Subject: Rezoning - Two Family Residential [R2]– 7,9,11 Cameron Road (portions of PIDs 00064402, 00064337, 00246868, 30019590)

Applicant:	Don-More Surveys and Engineering Ltd.	Property Owner:	L T S Investments Inc
Mailing Address:	520 Somerset Street Saint John, NB E2E 0E9	Mailing Address:	312 Rothesay Ave Saint John, NB E2J 2B9
Property Location:	7-11 Cameron Road	PID:	Portions of PIDs 00064402, 00064337, 00246868, 30019590
Plan Designation:	Medium Density Residential	Zone:	Single Family Residential – Standard [R1B]
Application For:	Rezoning to Two Family Residential [R2]		
Input from Other Sources:	Operations, Rogers

Rothesay's Planning Advisory Committee (PAC) has received an application from Don-More Surveys and Engineering on behalf of LTS Investments to rezone parcels of land having an approximate area of 4757 square meters located along Cameron Road (portions of PIDs 00064402, 00064337, 00246868, 30019590). The applicant is seeking a rezoning from Single Family Residential – Standard [R1B] Two Family Residential [R2].

Figure 1 – Portion of site to be developed with two-unit dwellings fronting on Cameron Road.

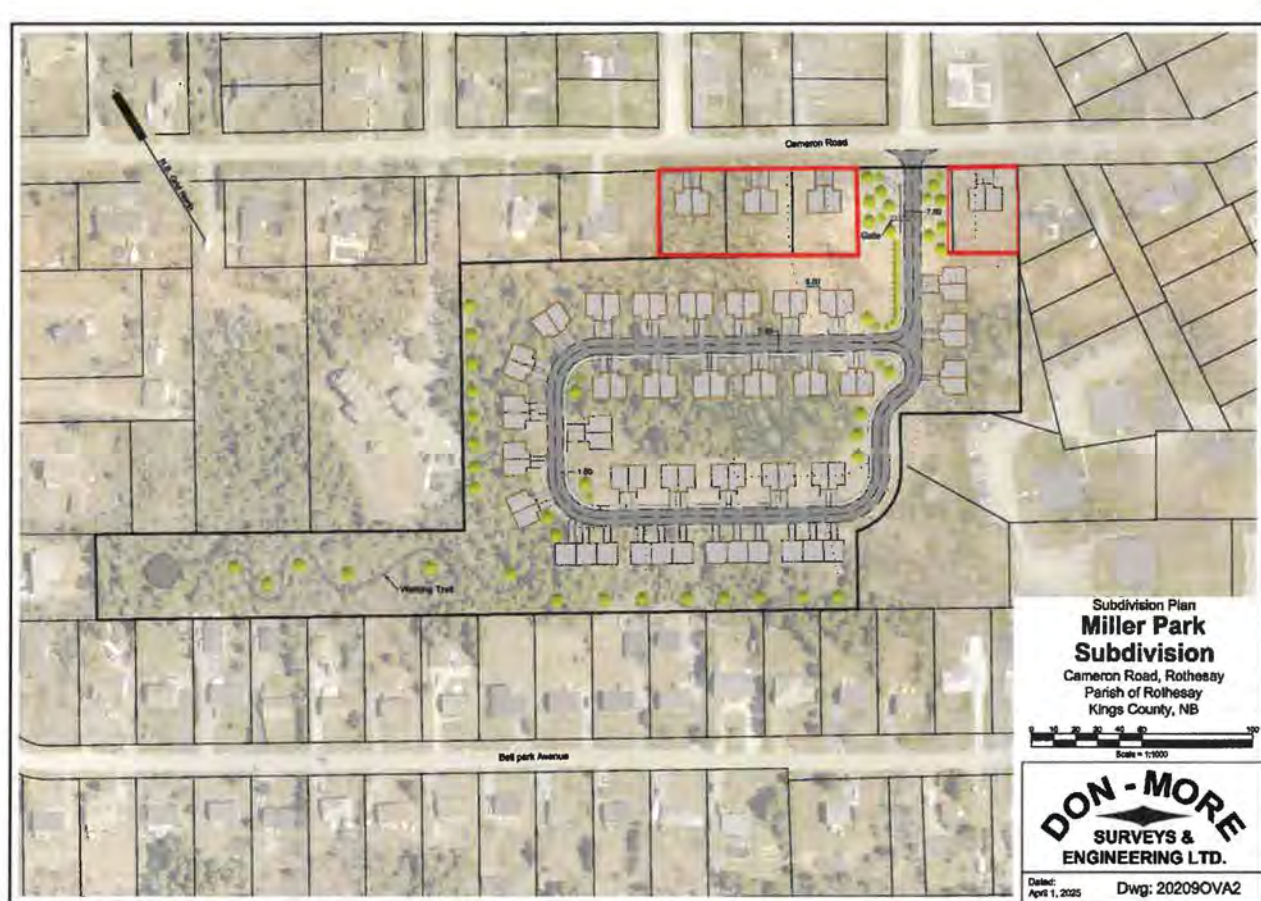
The site's existing zoning does not allow for two-unit dwellings. A rezoning is required to accommodate the applicant's proposal. The applicant is seeking a rezoning to Two Family Residential [R2] for the

four lots fronting onto Cameron Road (Lots 25-2, 25-3, 25-4, and 25-5) which would accommodate two-unit dwellings. Conformance with the R2 zone is assessed in Table 1.

Table 1. Conformance with R2 Zone Standards			
	Required	Proposed	Comments
Lot Size	1200 m ²	1188 m ² – 1190 m ²	A Development Officer variance will be issued in conjunction with approval of the Tentative Plan of Subdivision by the Development Officer (should the rezoning be approved by Council) to provide for the reduced lot areas.
Front / Rear Yard Setbacks	Front: 7.5 m Rear: 7.5 m	Front: 7.5 m Rear: 15 m	
Side Yard Setbacks	Major: 5 m Minor: 5 m	Major: 6.5 m Minor: 6.5 m	
Minimum Building Area	185 m ²	189 m ²	
Maximum Lot Coverage	35%	25%

Staff note the dimensional requirements of the R2 zone are met except for a variance for lot area. This variance will be processed as a Development Officer variance in conjunction with approval of the Tentative Plan of Subdivision by the Development Officer.

Although no landscaping details are provided, the Zoning By-Law requires that front yards shall be maintained with a minimum area of 60% in turf or other landscaping material such as trees, planting beds, hedges, and walkways.
